## Comments on the Botley West Solar Farm Scoping Report

### Shipton-on Cherwell & Thrupp Parish Council

July 2023

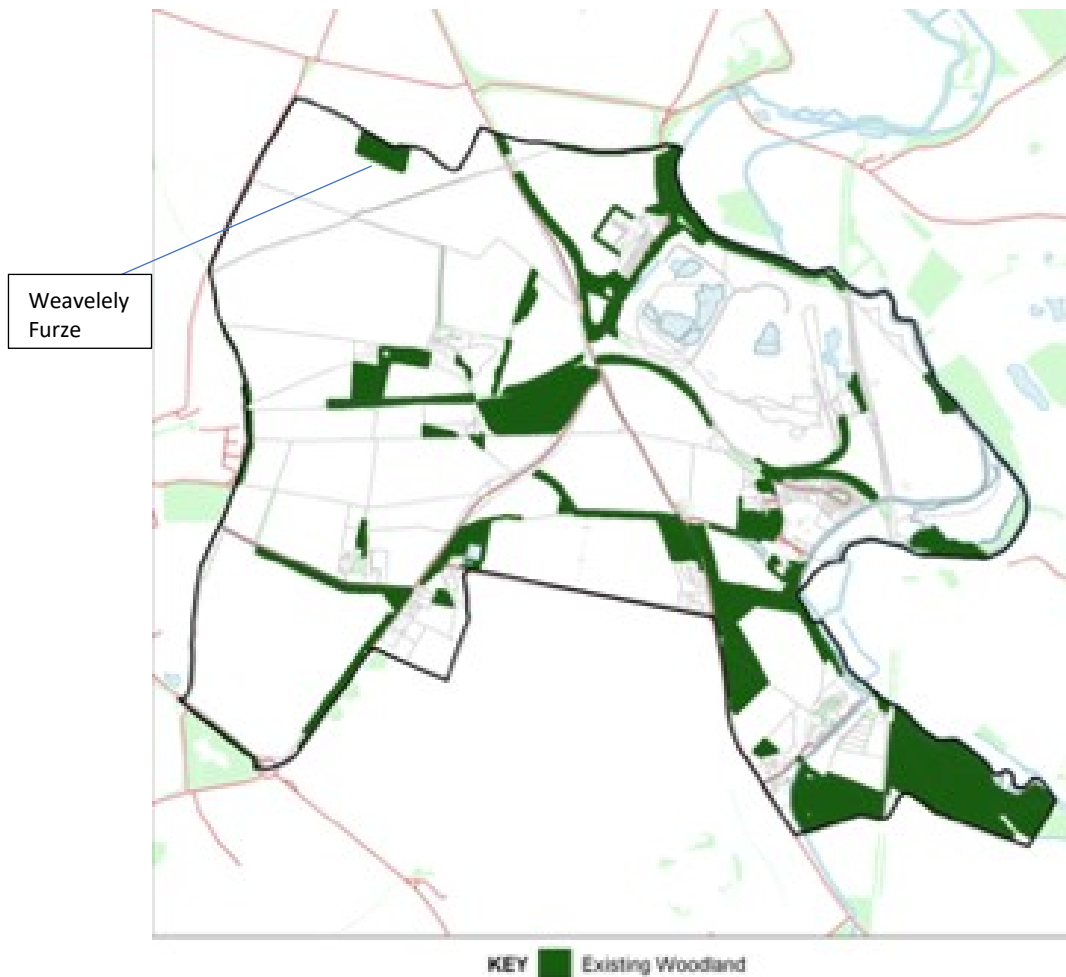
Our main concerns about this project mainly revolve around loss of amenity value to the parish community due to the proximity of the 316ha. Northern site to the Shipton-on-Cherwell & Thrupp parish boundaries, especially to the mature woodland known as Weaveley Furze which is an important local biodiversity "hotspot", especially for fungi, which are not mentioned at all in the scoping reports, and is also an important nature recreational site for the parish. We would request that special attention is paid to this location in the EIA especially with regard to wildlife movement, light pollution, visual amenity and overall landscaping/proximity. Weaveley Furze is a marked component of the [UK Nature Recovery Map](#). We do not have access to the entire Nature Recovery map but recommend that this be included in the

landscape/biodiversity component of the EIA to assess potential overlap of proposed Nature Recovery areas with BWSF.
